**LEBANON PLANNING BOARD
DECEMBER 8, 2025 - 6:30 PM
COUNCIL CHAMBERS, CITY HALL OR
REMOTE VIA VIRTUAL PLATFORM
LEBANONNH.GOV/LIVE**

Staff Memorandum – PB2025-51-BLA

Application ID: PB2025-51-BLA

Eric C. Mitchell & Associates, Inc. (ECM) is writing this letter in response to a review letter received from the City of Lebanon Planning & Development Dept, dated November 17, 2025. The comments are repeated below in *italics* with our response and/or action below each comment in **bold**.

For reference, here is an image of the previously approved landscaping plan for PB2024-48-SPRCUP, (which, even still, required the granting of partial waivers from the Section 6.2 landscaping requirements):

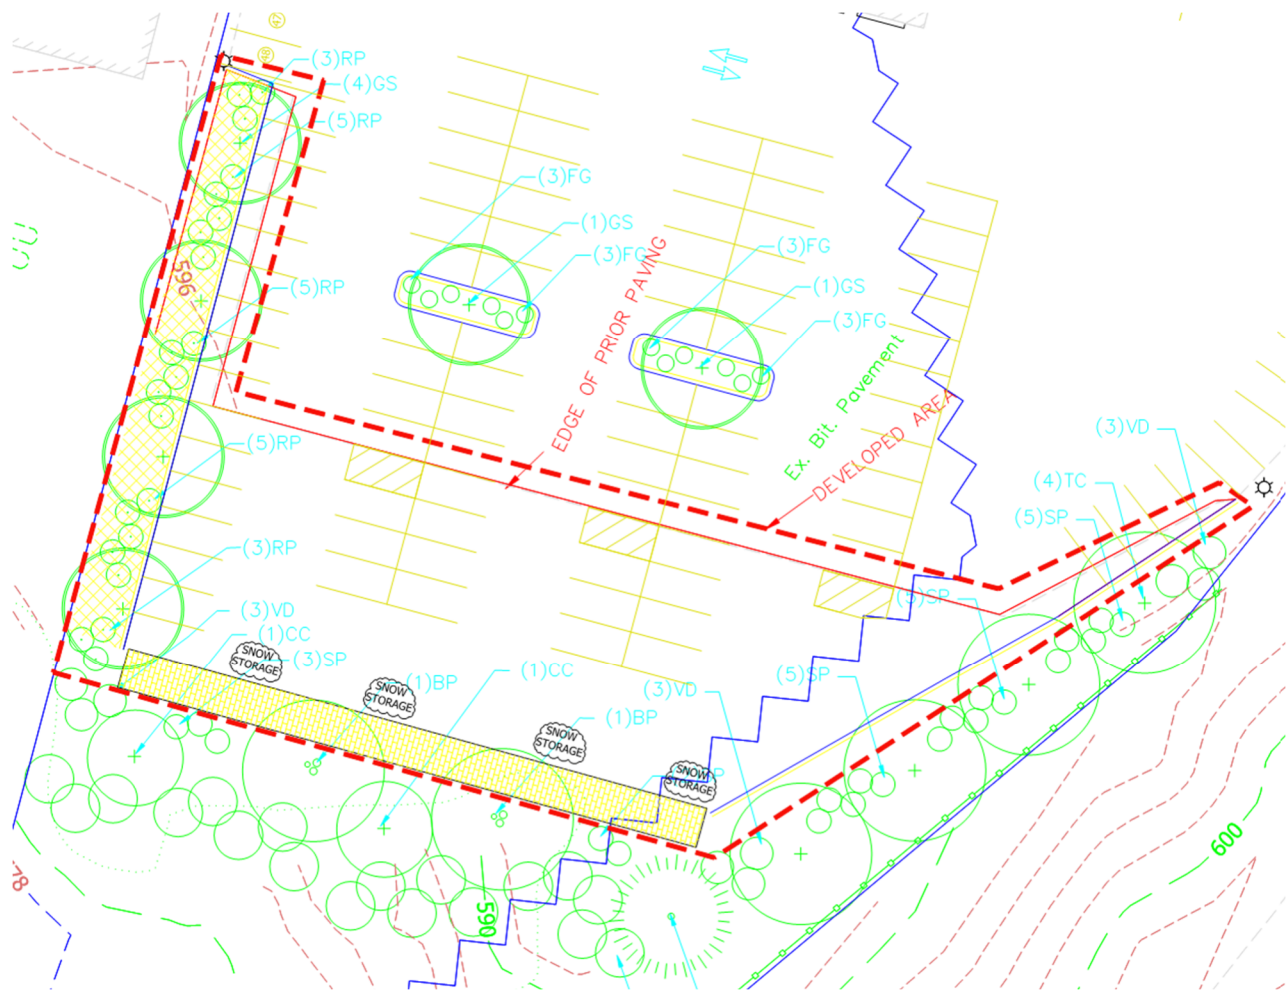
6.2 (Landscaping Standards): No landscaping is proposed in connection with the proposed expansion. The applicant has requested waivers from the requirement to provide a landscaping plan, the perimeter landscaping design requirements, and the parking area design requirements. Staff does not support the requested waivers and recommends that the Planning Board require full compliance with the perimeter and parking area landscaping requirements within and along the proposed expanded parking area.

Cover Sheet

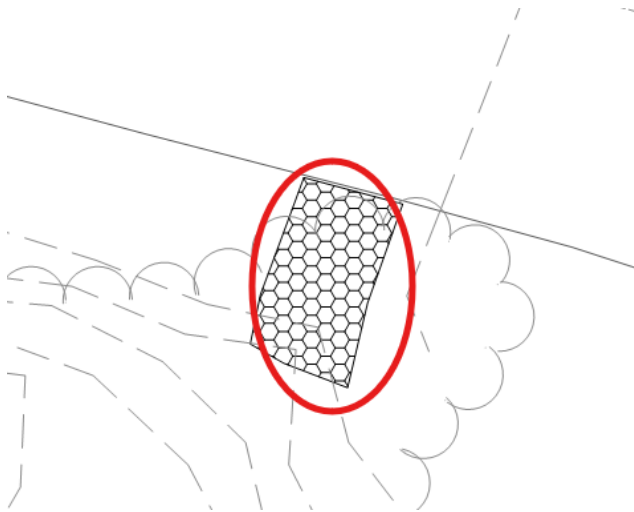
22. Add a note indicating that the plan is approved pursuant to the City of Lebanon Site Plan Review Regulations last revised April 28, 2025 and the City of Lebanon Zoning Ordinance last revised March 19, 2025. The note has been added to the cover sheet

23. Add Planning Board application number (PB2025-52-SPA). *The note has been added*
24. Identify the plan that the proposed “site plan amendment” is amending. *The site plan is now labeled “Site Plan”*

Sheet 4 (Site Grading and Drainage Plan)

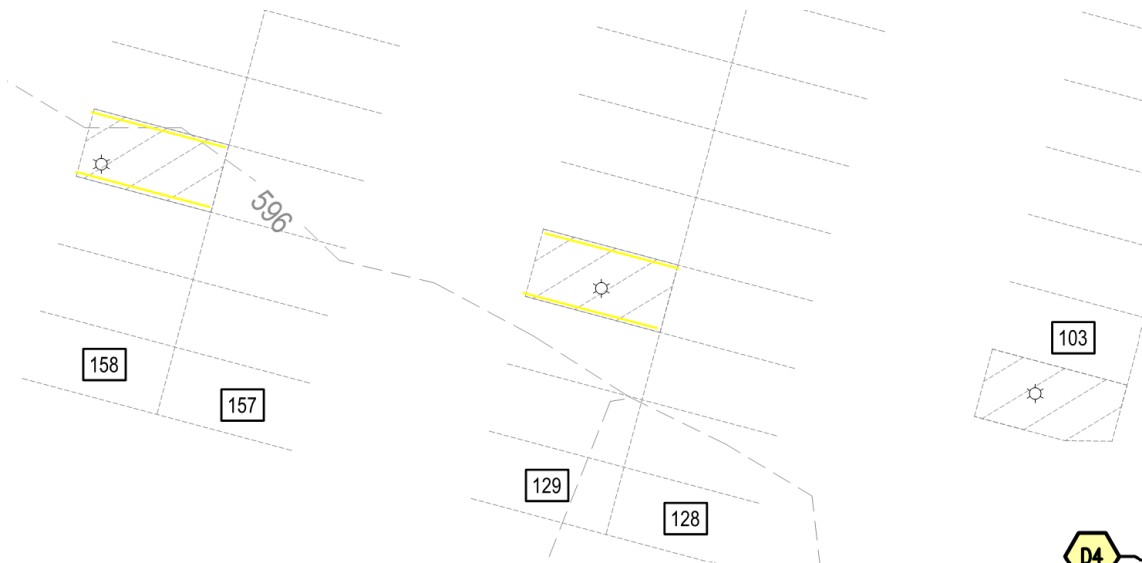
33. Outline the development area, i.e. the area of the property that is the subject of the current application (see comment #9 above). **The previous edge of pavement is now depicted on the plan which delineates the development area**
34. Do the solid lines indicate that these will be striped? **All striped hatch is to be striped**
